Resolution No. 2026-3481

**Re: Sanford Fire Station #40
 COP #035 - Offsite Line Stop (RFI #95)**

TO: Honorable Mayor and Members of the City Commission
PREPARED BY: Ronnie McNeil, Fire Chief, CFO
SUBMITTED BY: Norton N. Bonaparte, Jr., ICMA-CM, City Manager
SUBJECT: Approval of Resolution No. 2026- 3481; Change Order Proposals

Requesting to approve Resolution No. 2026-3481 to amend the capital budget in the amount of \$381,157 for the procurement of the Change Order Proposals for Fire Department Station 40.

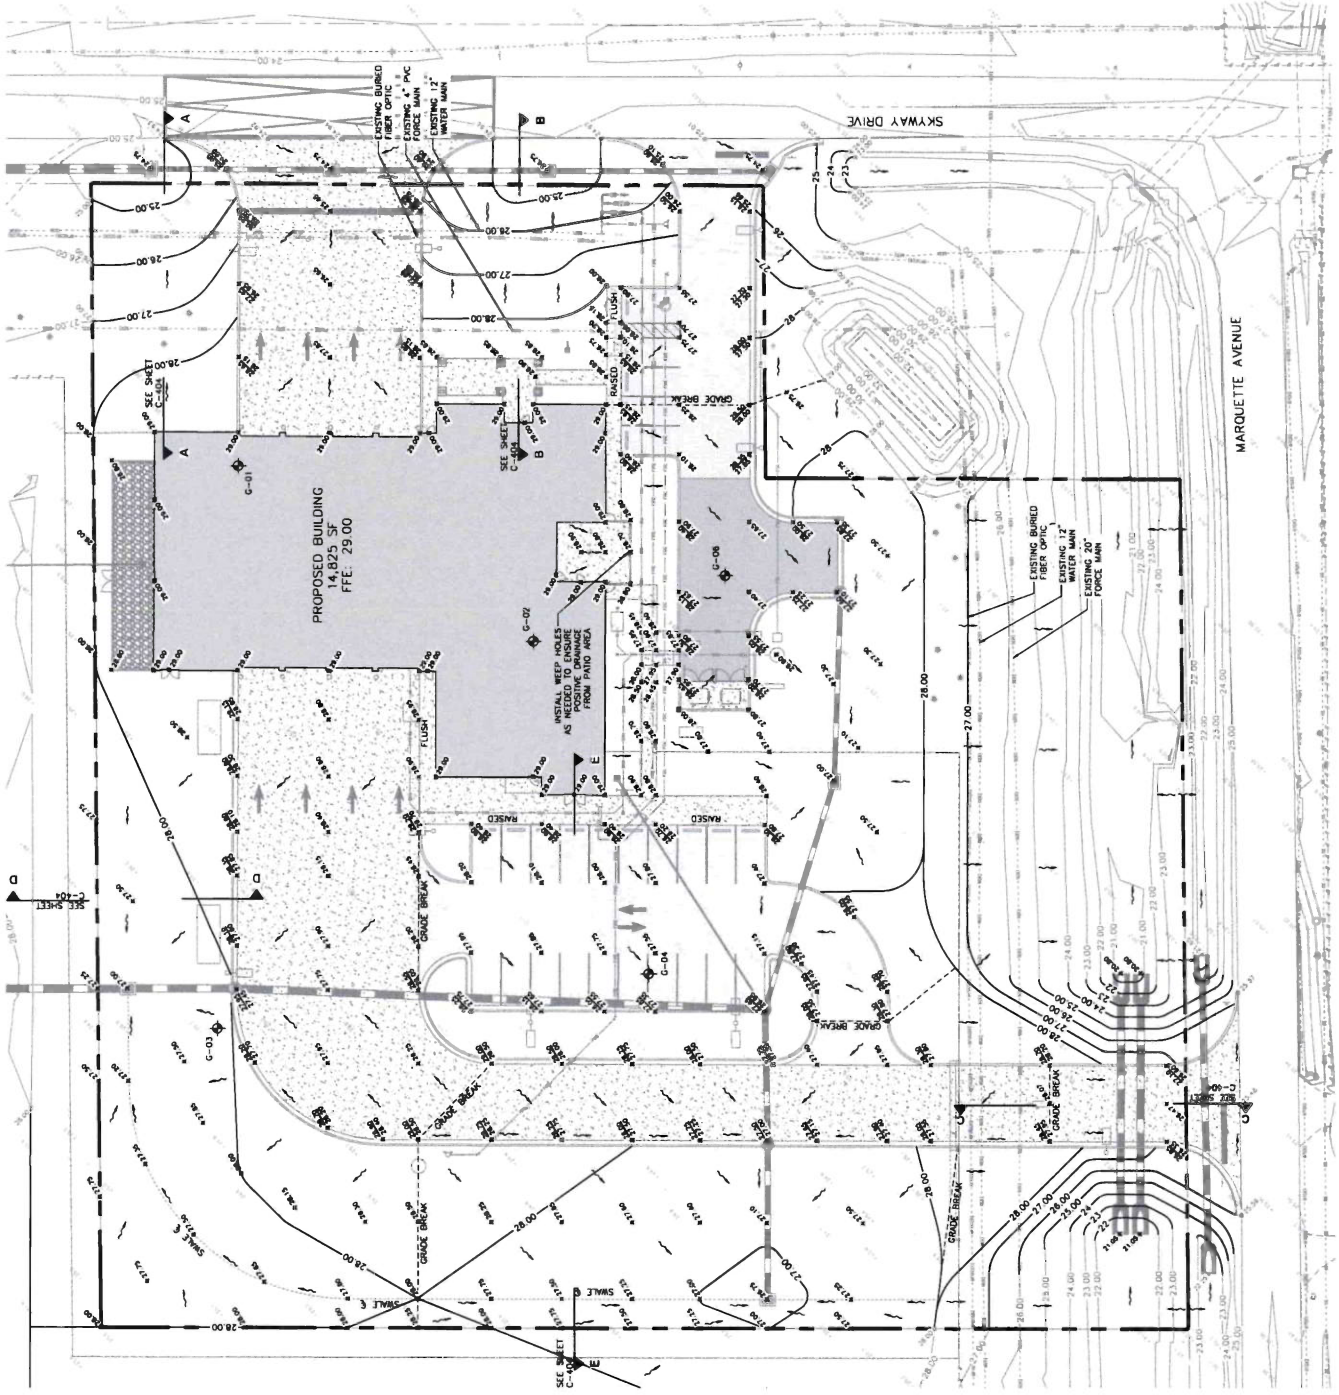
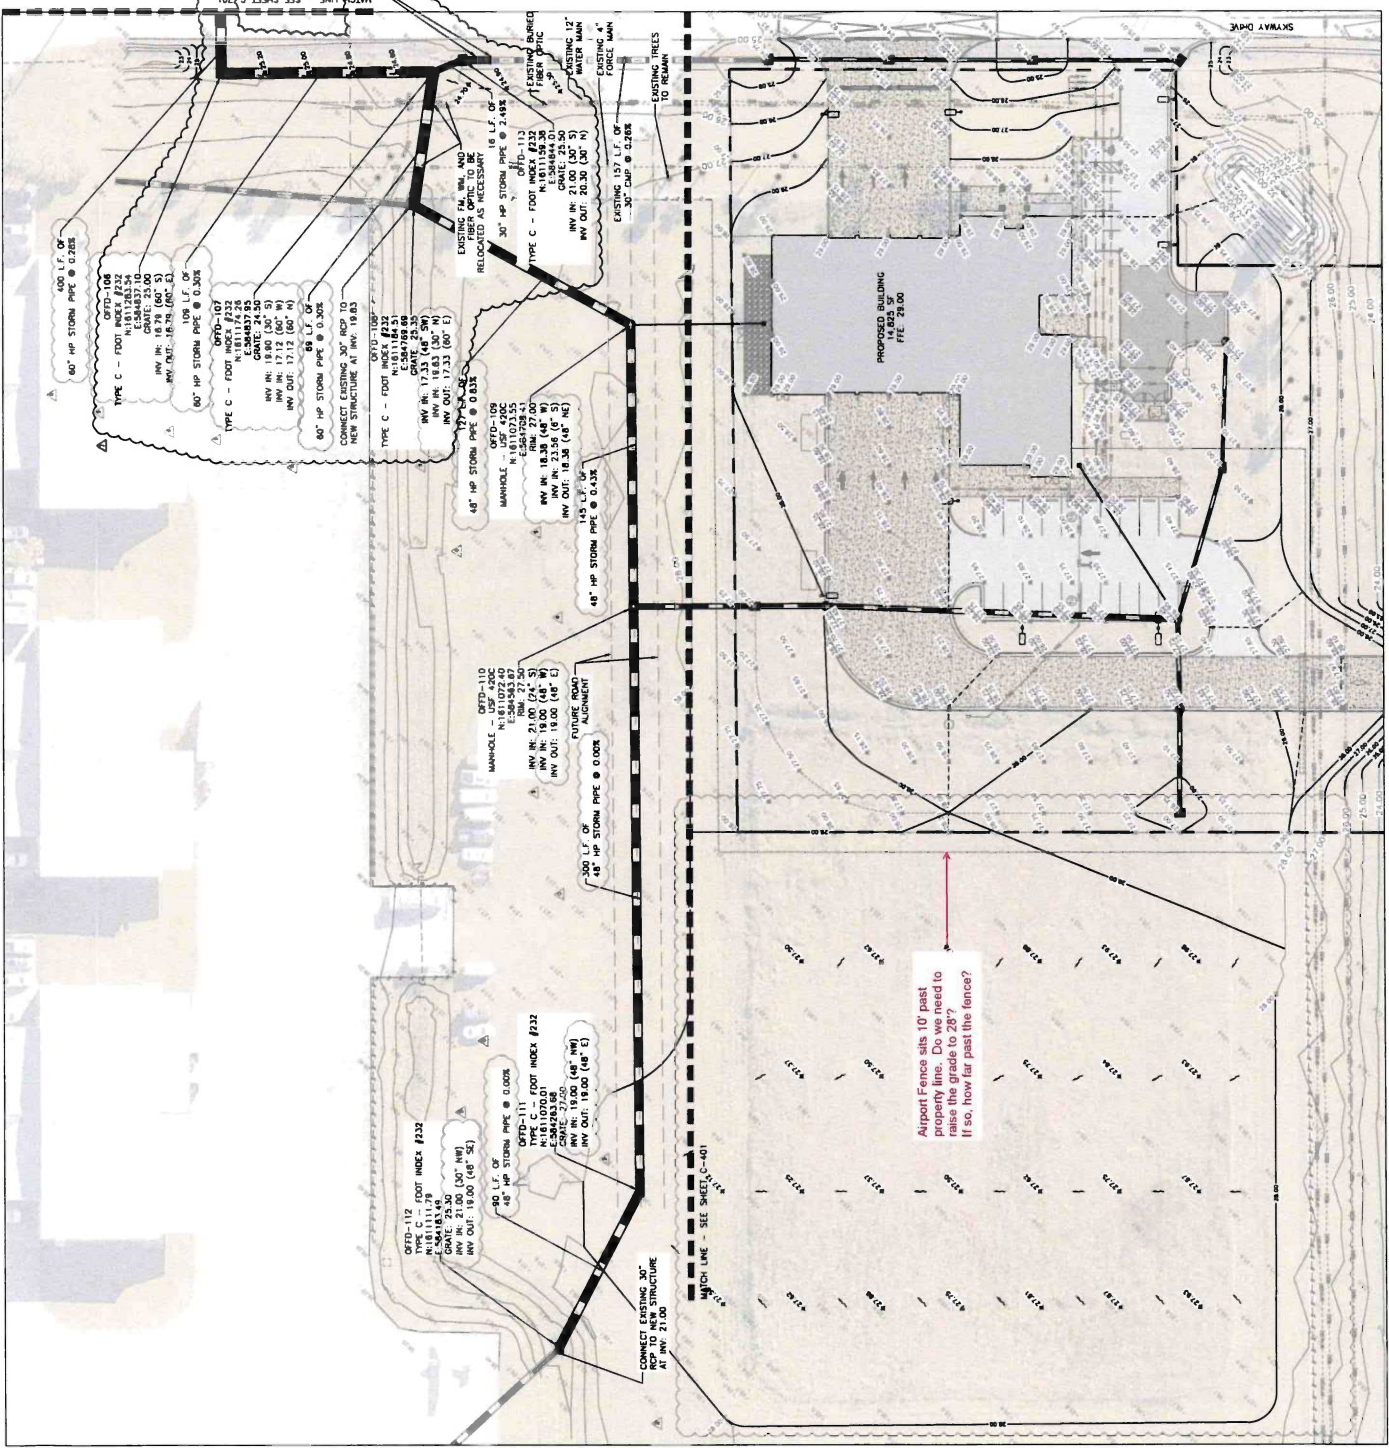
Field requests verification of the extents of the Fire Station pad and Airport Fence specifically with regard to elevations and locations. If dry pond is not being filled in, please clarify the details for the edge of the dirt grade and fence location and elevation.
